## **MERCER MIDDLE SCHOOL**

### **DESIGN DEPARTMENT RECOMMENDATIONS**

**Project #3039303-SD**

**September 27, 2022**

#### **Departure #1 – Greater than Allowed Building Height**

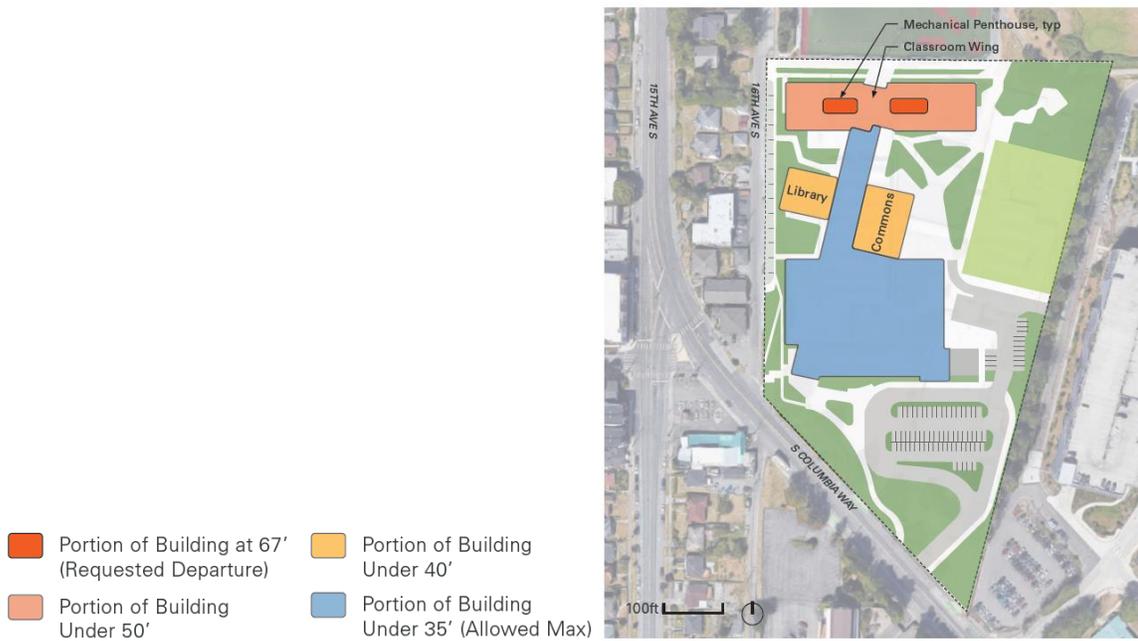
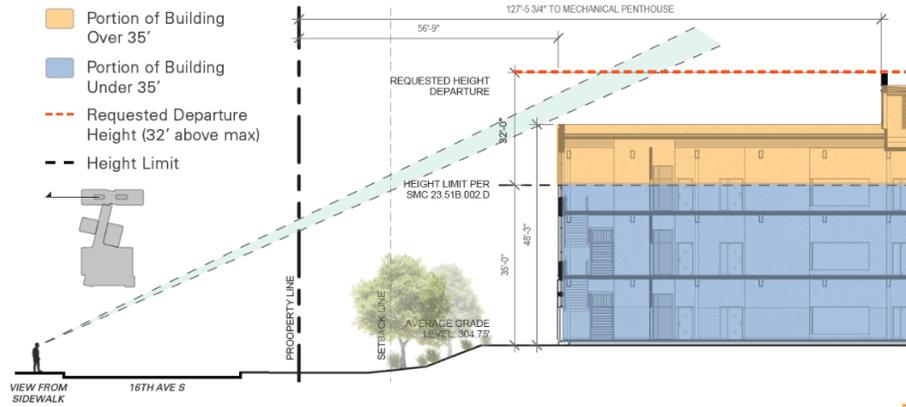
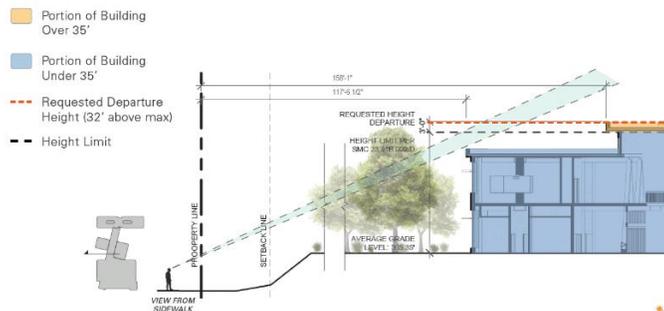
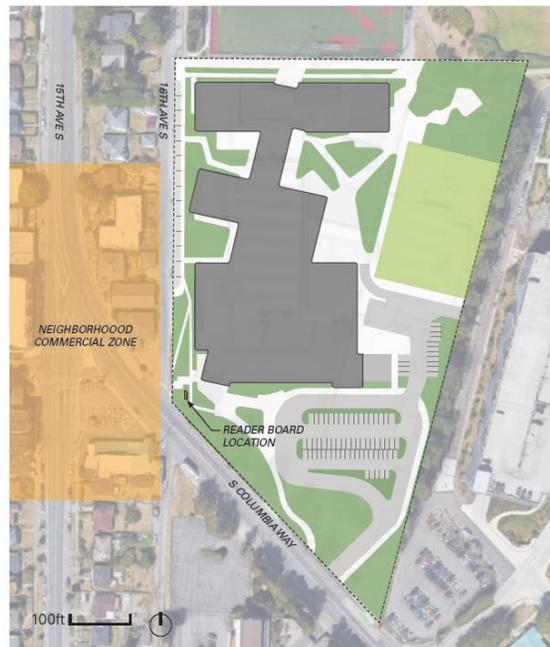
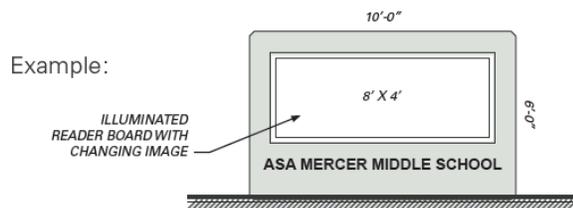
DON received one comment on this departure. The comment was critical of the zoning height maximum of 35' and advocated for a city-wide policy change that would adopt a minimum zoning height, not a maximum.

**Recommendation 1 – That the departure to allow greater than allowed building height to be GRANTED as requested by SPS.**

### Departure #3 – Increase fence height within setbacks

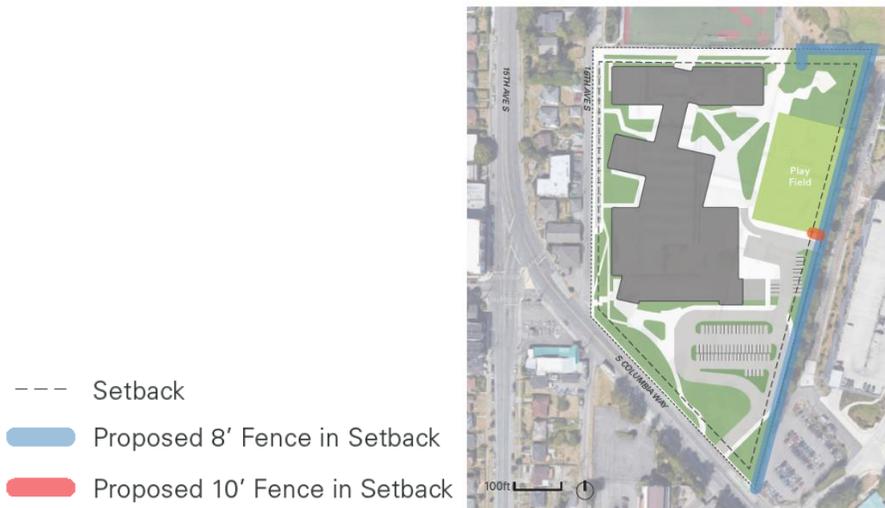
DON received no comments critical of this departure.

**Recommendation 3 – That the departure to replace the existing fence along the East edge of the property with an 8-foot fence for security purposes, and a 10-foot fence along the South edge of the soccer field to prevent balls from going past the field be GRANTED as requested by SPS.**
